April 8, 2016

Reference: 601-685 Washington Avenue (PB 2320) Sound Study Peer Review

Nighttime Ambient Sound Level Measurements 601 Washington Avenue, Miami Beach, Florida

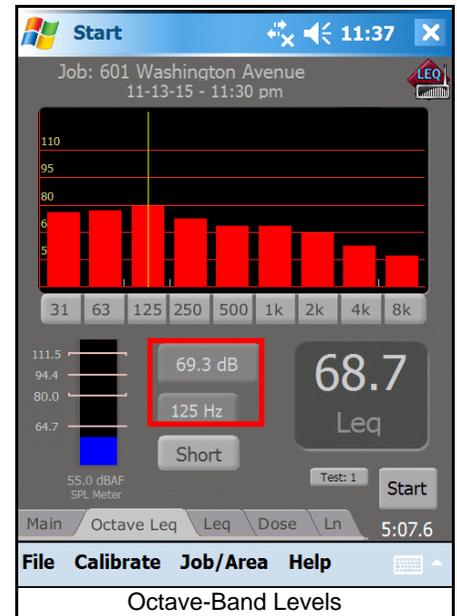
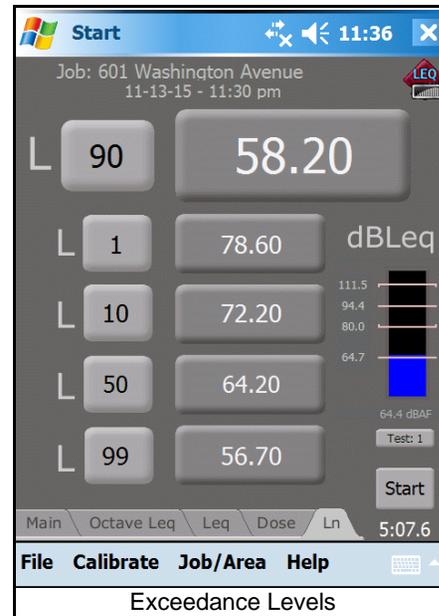
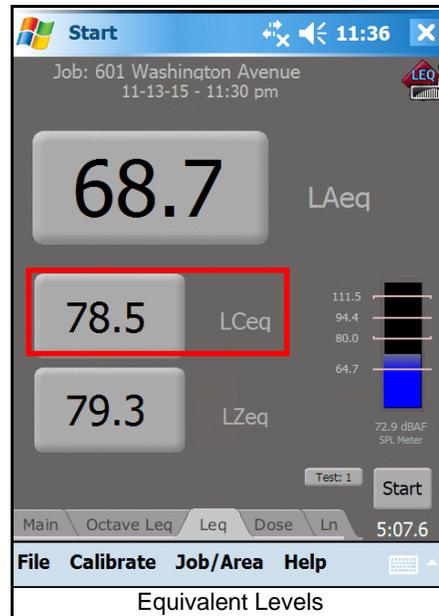
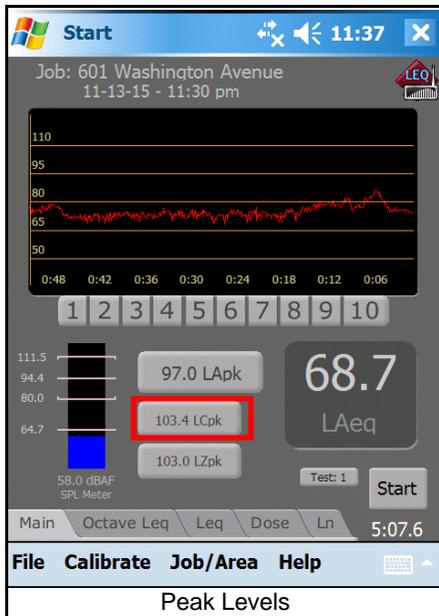
While the two sets of measurements—one of 5-minute duration at the southeast corner of Washington Avenue and 7th Street and one of 30-minute duration along Washington Avenue—provide some information about the soundscape in the vicinity, they are not sufficient to draw conclusions related to impact upon the Arcadia House Condominium.

First, while A-weighted decibels are a ubiquitous metric used to describe sound levels both within buildings and in the environment, where music, particularly that produced by live musicians and DJs, is a source, C-weighted levels (dBC) should be considered as a complement to A-weighted levels. This is due to the fact that C-weighted levels more accurately characterize sound with significant low-frequency content. Should there be any nuisance issues in this case, it is likely that they would be from low-frequency sound (e.g., thumping bass).

Finally, and most importantly, no measurements were made at or near the façade of the Arcadia House. An L90 of 57.4 dBA was reported along Washington Avenue; however, the façade of the condominium is set back approximately 75’ to 100’ from Washington Avenue. It is quite likely that ambient levels that would tend to mask sound from the rooftop pool deck would be 5 to 10 decibels lower at the building façade than along Washington Avenue, assuming that traffic is the most prominent source, as the report states that it is. It is this lower sound level at or near the building façade that should form the basis of any audibility or impact assessments.

While A-weighted sound level data are the most commonly used metric for characterizing noise, our report also presents C-weighted data in both the sound level data (pages 5 and 6) and computer modeling of predicted sound distribution (pages 9 and 10). This allows an apples-to-apples comparison of noise levels generated by traffic versus music from the rooftop venue. Traffic and other ambient noise sources contain significant low frequency energy as illustrated in the data provided. C-weighted noise levels measured during the site study were consistently 10 dB higher than the A-weighted data. For example, during the shorter testing period, L_{Ceq} registered 78.5 dBC while L_{Aeq} registered 68.7 dBA (see Equivalent Levels graphic on page 6). The Octave-Band Levels graphic on the same page indicates an accumulated sound level of 69.3 dB in the 125 Hz octave, where much of the low frequency energy in music resides.

Portions of the measurements taken along Washington Avenue did include sampling of sound levels in the parking area outside the Arcadia House. Since we were mostly interested in obtaining an overview of the areas around the residential properties, no stationary measurements were conducted. It's not likely that data obtained at static test locations would yield significantly different results than those obtained while moving around the area along Washington Avenue. This is a very busy artery with heavy traffic present well into the early mornings.

Sound Propagation Map
601 Washington Avenue, Miami Beach, Florida
(Unweighted)

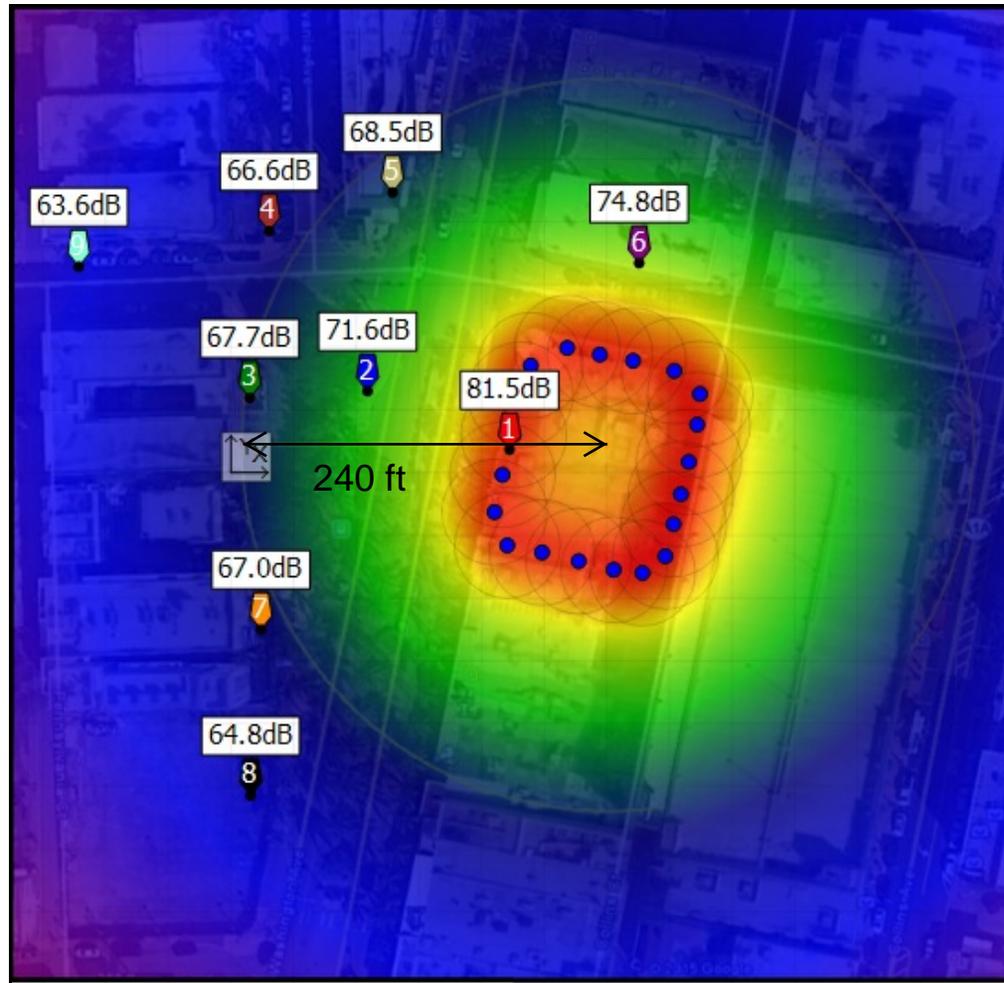
The computer model results provide a very informative visual representation of the propagation of sound from a hypothetical sound system comprising 20 loudspeakers distributed about the pool deck. The model assumes a program level of 82 decibels (unweighted), presumably at 10'. What is unclear is whether this system will, in fact, be the system that is installed and whether this system and its parameters will be implemented, not only for background music, but also live and DJ entertainment. If not, then one or more supplemental models would need to be developed for those scenarios.

Additionally, while we have no reason to question the results of the modeling, the conclusions drawn from it would need to be adjusted in light of our earlier point concerning what the actual sound levels are at the condominium façade. In other words, modeling results should not be compared to an L90 of 57.4 dBA measured near Washington Avenue when assessing impact on the condominium. They should, instead, be compared to the likely lower ambient (L90) sound level at the condominium, some 75' to 100' away from Washington Avenue. In fact, the report predicts a level, from the sound system, of approximately 62 dBA at the condominium façade. This is higher than the 57.4 dBA L90 near the street. It would be even more prominent against the likely lower ambient level at the condominium.

In addition to this, the figure showing predicted sound system levels indicates levels in the low 70s (dBA) at a distance of 100', near Washington Avenue. This is significantly over the L90 of 57.4 dBA measured in this area. This is salient given the fact that the Miami Beach noise code states the following:

The hypothetical system design used in modeling sound propagation should be considered a worst-case scenario. Omni-directional loudspeakers were used and no effort was made to interrupt sound from these devices via structural elements on the rooftop. As stated above, speaker size and type (see specification) will prevent significant low frequency energy (thumping bass) from being generated by the system, avoiding exposure to this type of energy at any of the surrounding properties. The loudspeakers will be mounted below the top of the rooftop parapet and oriented so as to direct most of their output towards the center of the pool deck, further mitigating the amount of energy that will escape the rooftop.

As stated above, the most restrictive hours referred to in the ordinance are those between 11:00 p.m. and 7:00 a.m. In recognition of this criteria, the rooftop venue will restrict entertainment to between 11:00 a.m. to 8:00 p.m., after which the system will operate at background levels. Sound levels generated on the roof will be much lower, therefore music will not be audible outside the rooftop venue.

INDOOR RESTAURANT & OUTDOOR CAFE

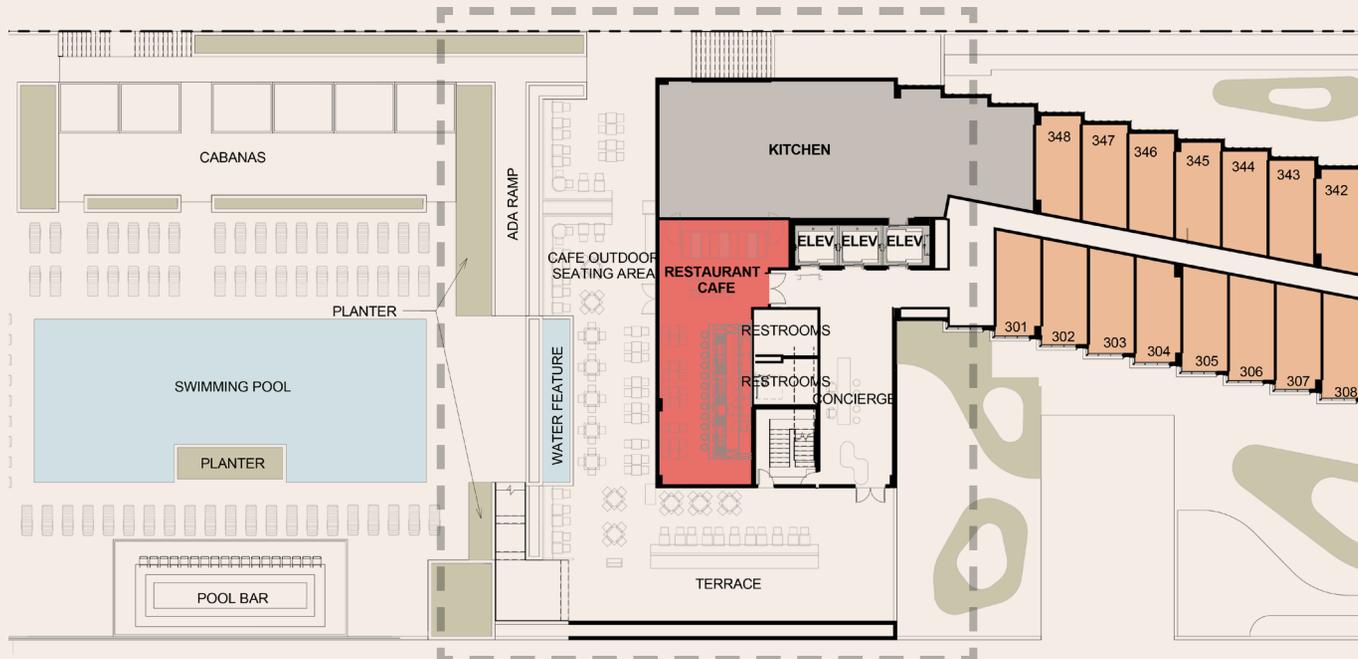
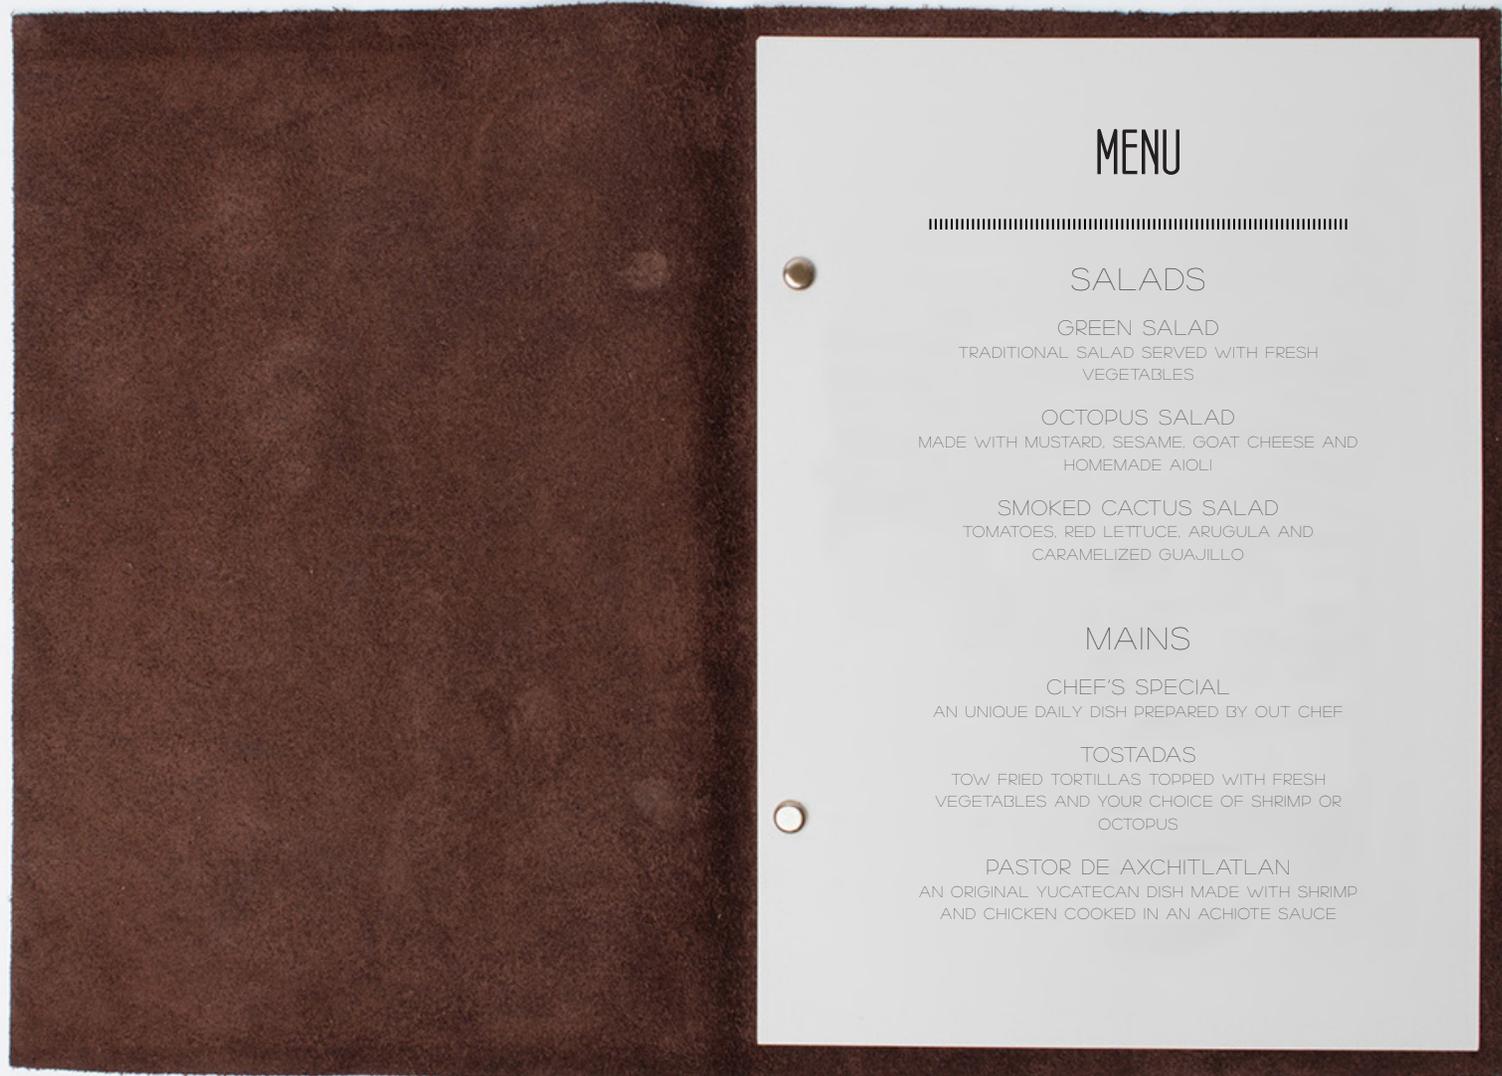
The report briefly mentions an interior restaurant where entertainment level music is being proposed. However, aside from this reference, no other information is given. In order to assess potential impact, one would need information such as restaurant location, enclosing construction, anticipated interior sound levels, and an estimate of sound transmission through any intervening building components.

The restaurant design is detailed on pages 6, 7 and 10 of the Proposed Operational Plan. Hours of operation are included on page 19. Hours of entertainment inside will extend from 11:00 a.m. to 1:00 a.m. Construction is a combination of concrete and storefront glazing with a single door opening onto the outdoor seating area. The restaurant space is quite small, seating 76, and may not lend itself to having an area where a stage could be provided for entertainment, even a DJ.

While we cannot provide exact details relating to anticipated sound levels inside the restaurant nor sound transmission loss from inside to the outside at this time, this portion of the system will undergo the same process of calibration and tailoring of these parameters prior to be certified as complete. This will include inspection by members of the City’s Planning Staff. We do not anticipate that activities within this space will be problematic.
